Product Change Notification

■ Delivery Unit Change – 44242-00XX Family — Micro-Fit 4-24 Circuit Test Plug Assembly

Before Picture

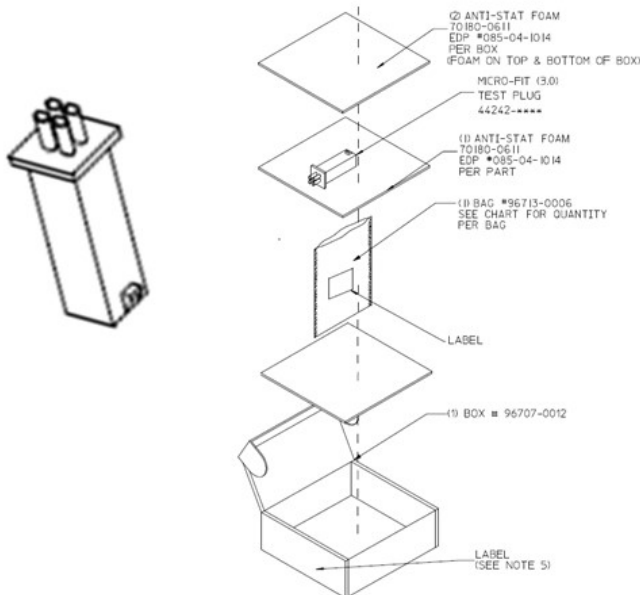
- Global Delivery Unit on the Micro-Fit 4-24 Circuit Test Plug Assembly is being set to 1pc
 - This will align the Global Delivery Unit with PK-44242-001
- There is NO impact to Fit, Form or Function of product
- Delivery Unit change only, no samples or PPAP will be provided for change.
- Part Numbers Impacted
 - See attached list
